**SECTION 00 90 03  
BIDDING AND CONTRACT REQUIREMENTS  
ADDENDUM NUMBER 3**

**Re: ADDENDUM NUMBER (3) TO THE BIDDING DOCUMENTS FOR**

**Student Farm Renovations  
Issued for Bid**

Architect's Project Number: 25-037

SHEET NUMBER:  
**C-02**

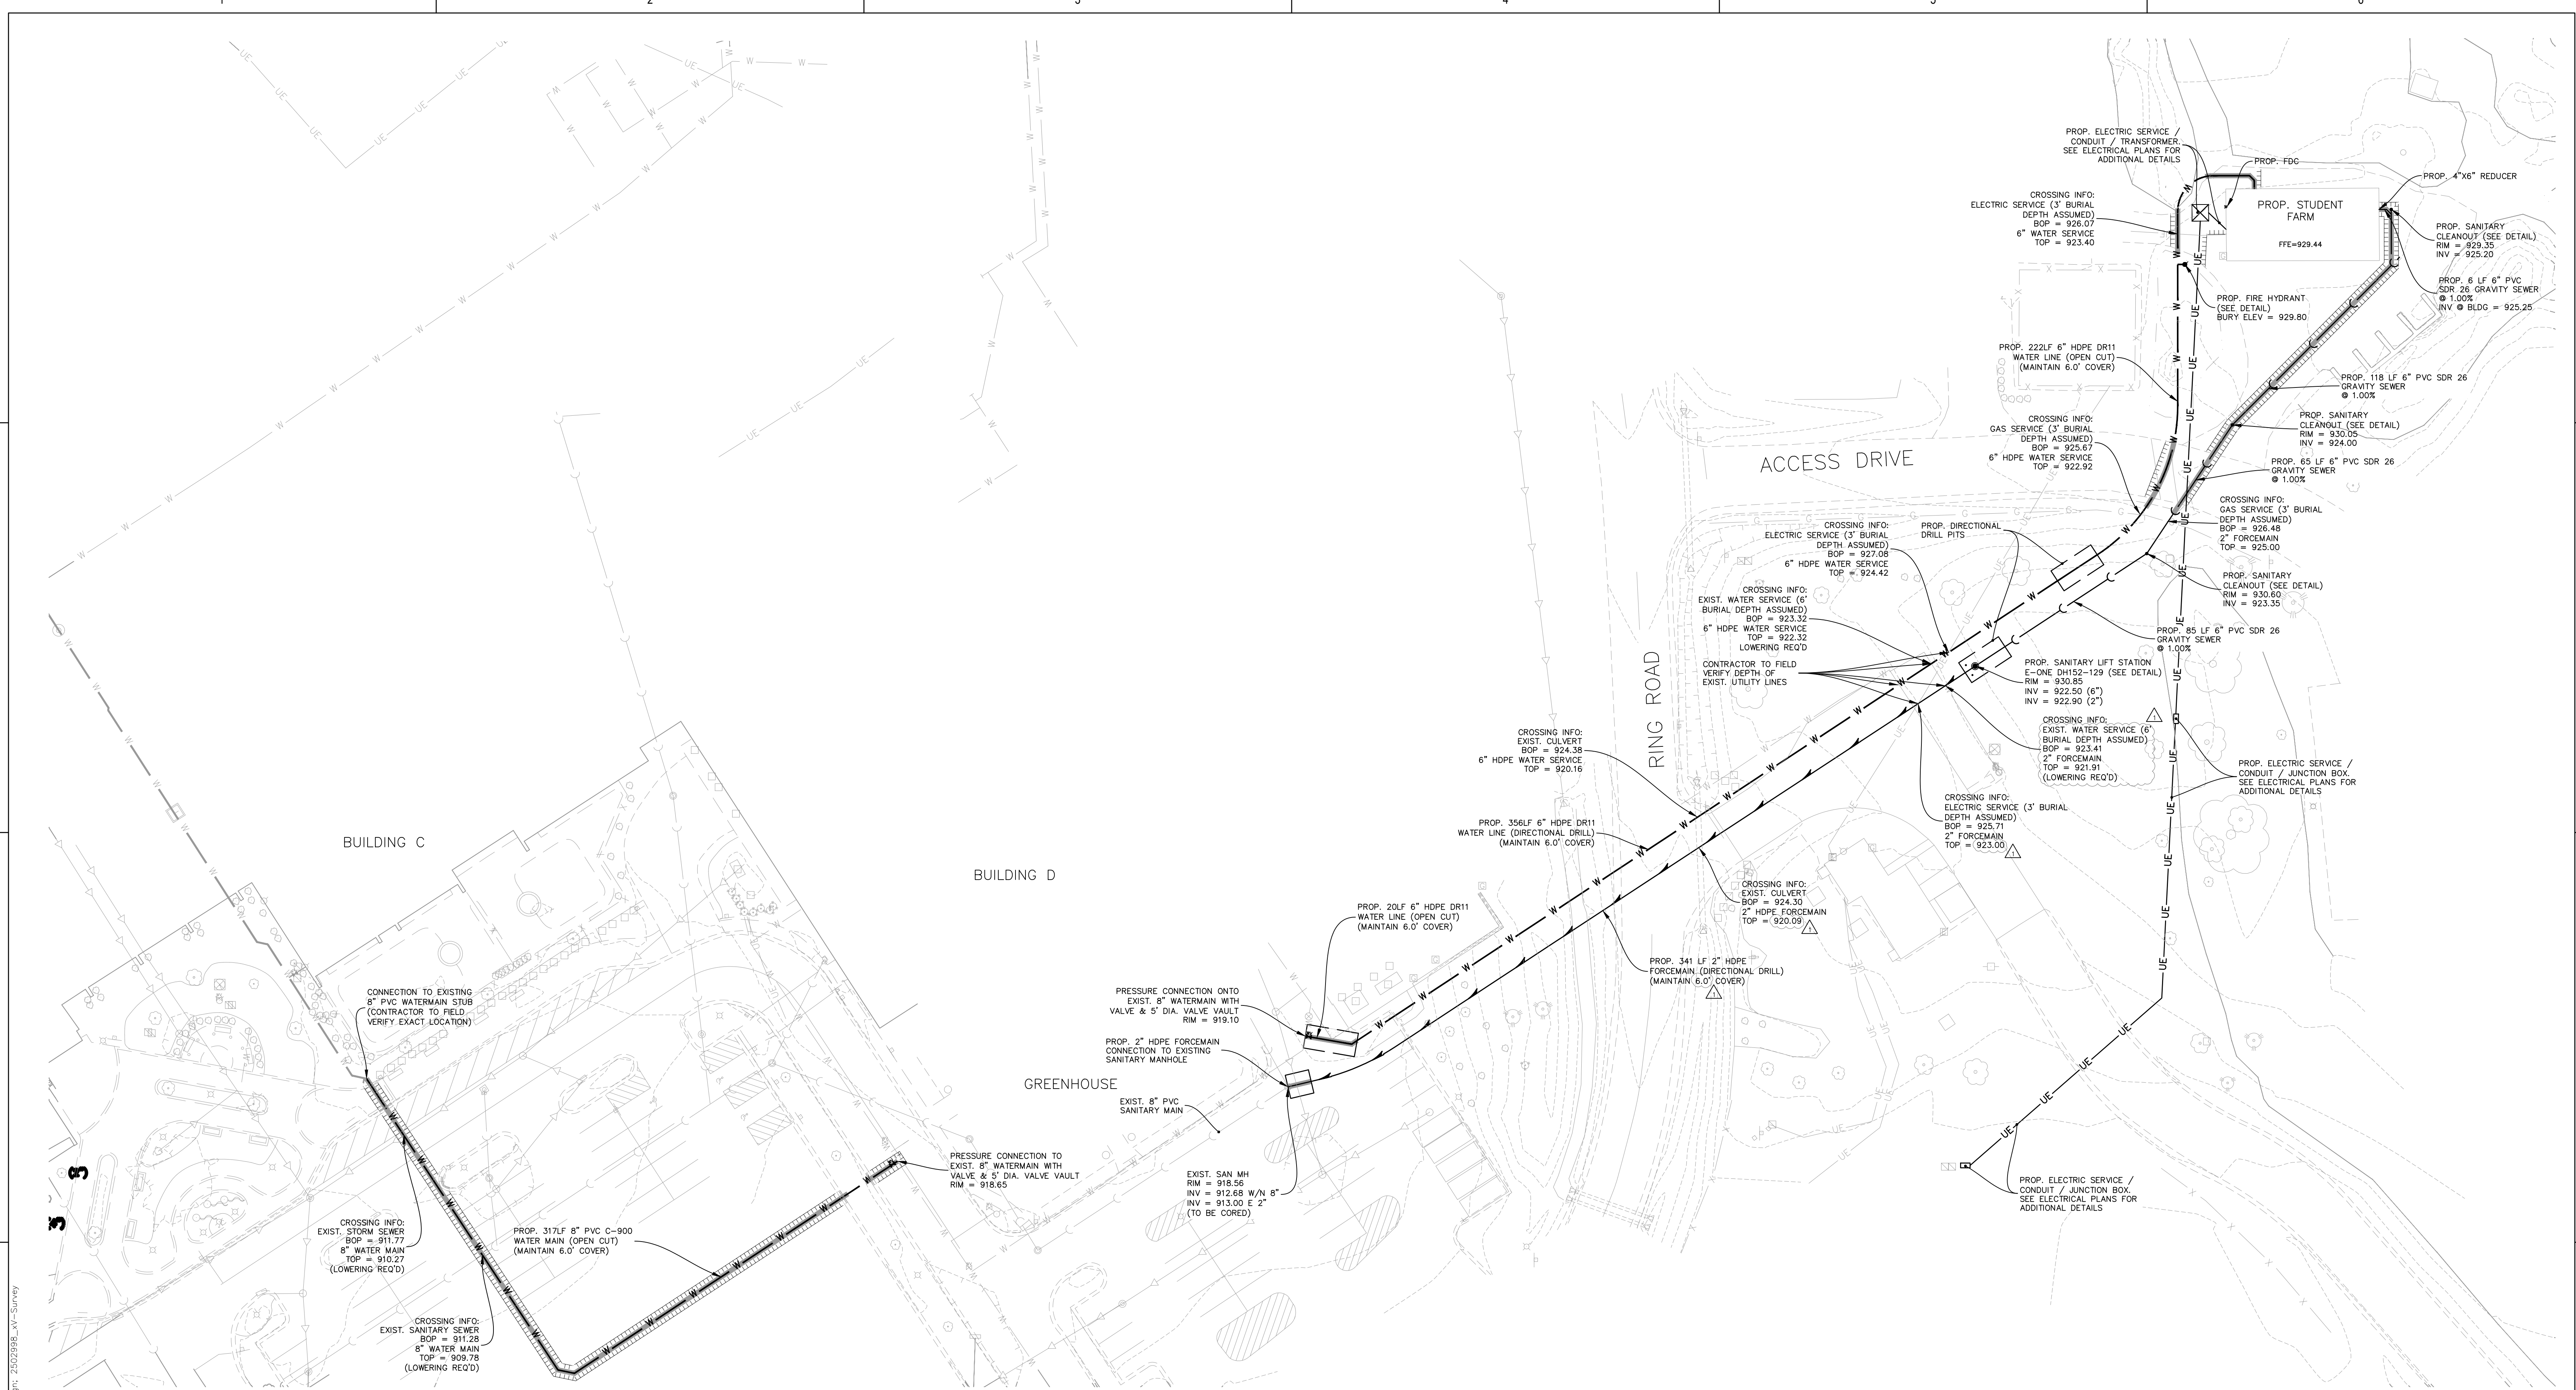
1. C-0
  - A. **REVISE** note #40 regarding haul off of excess material
2. C-02
  - A. **ADD** note to removal tag R-8.
  - B. **ADD** information to tank removal note.
  - C. **ADD** temporary construction fence and associated notes.
3. C-04
  - A. **ADD** hatch for limits of utility trench backfill and associated hatch legend.
  - B. **ADD** utility spoils note.
  - C. **REVISE** minimum bury depth for sanitary forcemain pipe.
  - D. **REVISE** sanitary forcemain crossing information & notes

SHEET NUMBER:  
**A10.00**

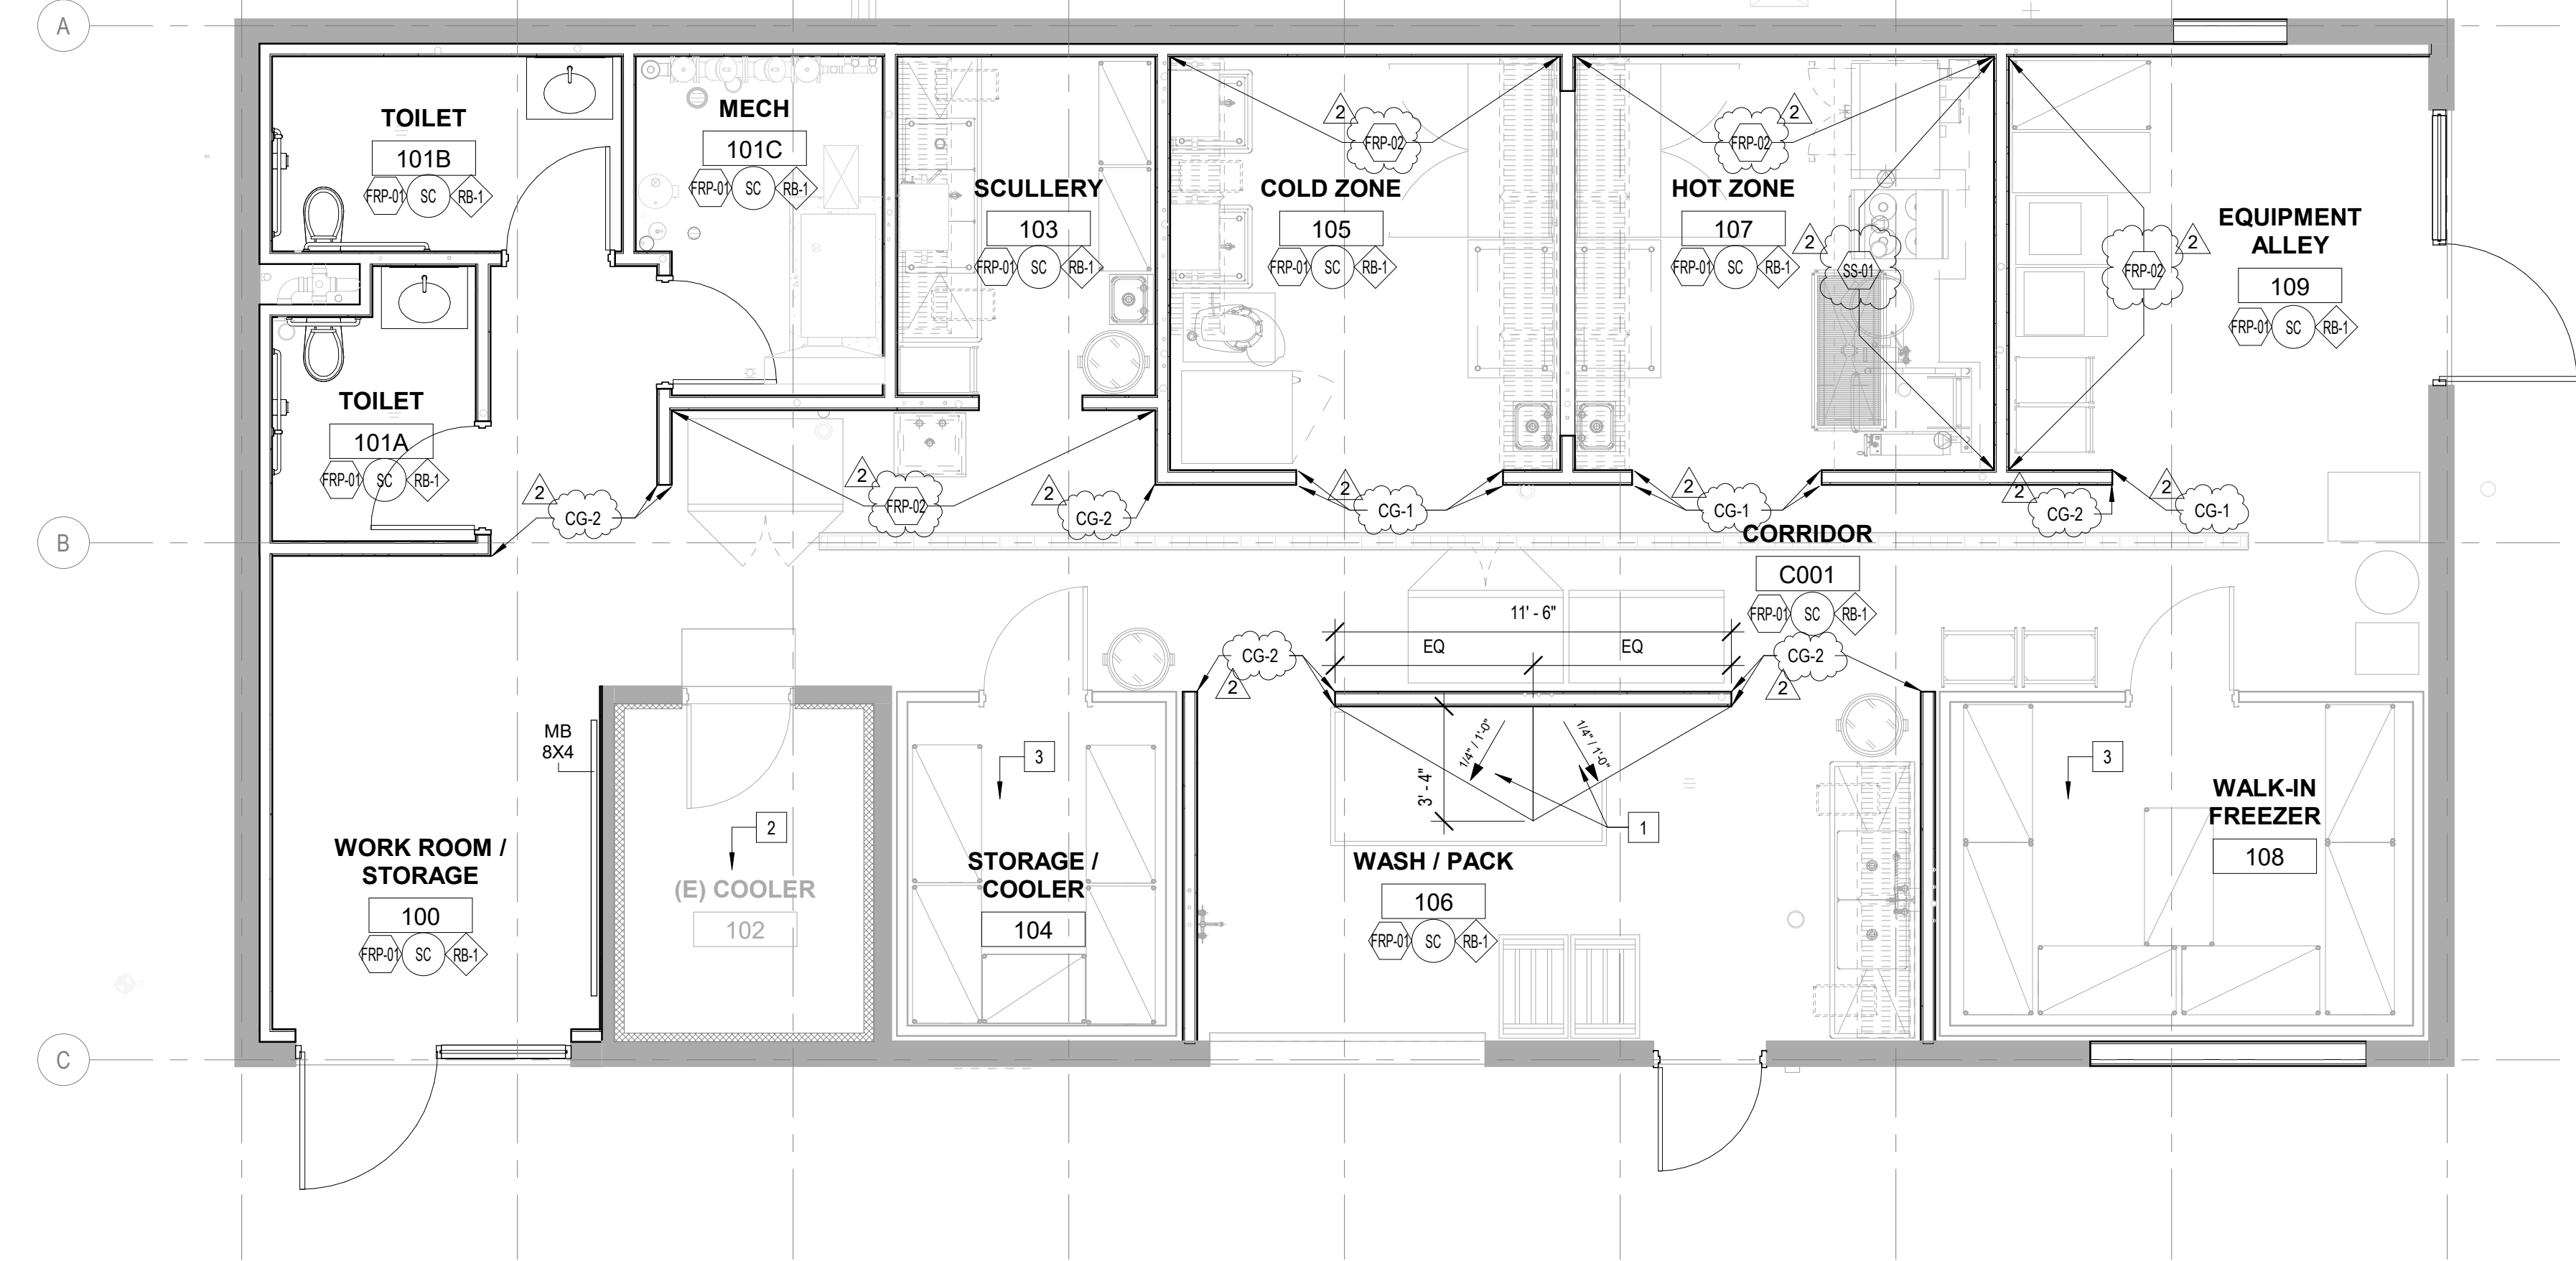
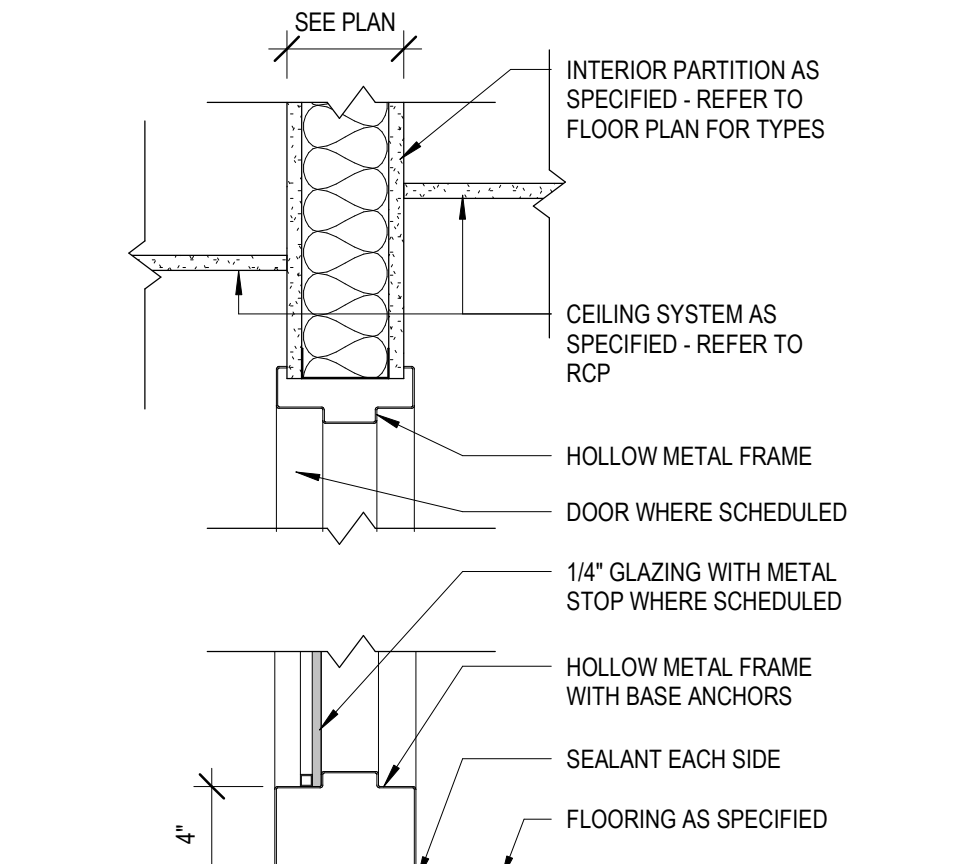
3. A10.00
  - A. **DELETE** remarks on Door and Frame Schedule – New Work.
  - B. **DELETE** doors 100.1(E), 106.1(E), and 109.1(E) from Door and Frame Schedule – Existing to Remain

- C. **REVISE** door tags as shown on schedule.
  - D. **REVISE** Window Elevation A to show frame typ. frame width
4. A11.01
  - A. **REVISE** Finish Plan General Notes to include paint color as indicated.

- A. **RESPONSE:** There is no wall tile on the project.
6. PRE-BID RFI #14: Please verify the face size of window elevation A on drawing page A10.00. While the standard type A frame elevation dictates a 1 3/4" face, drawing A10.00 does not provide a specific dimension for the face size of the window elevation A unit. Please confirm if the window elevation A frame should also be 1 3/4" or provide the correct dimension if it differs from the standard type A frame.

- A. **RESPONSE:** The face frame width will be 1 3/4" for elevation a doors. Refer to attached for clarifications.
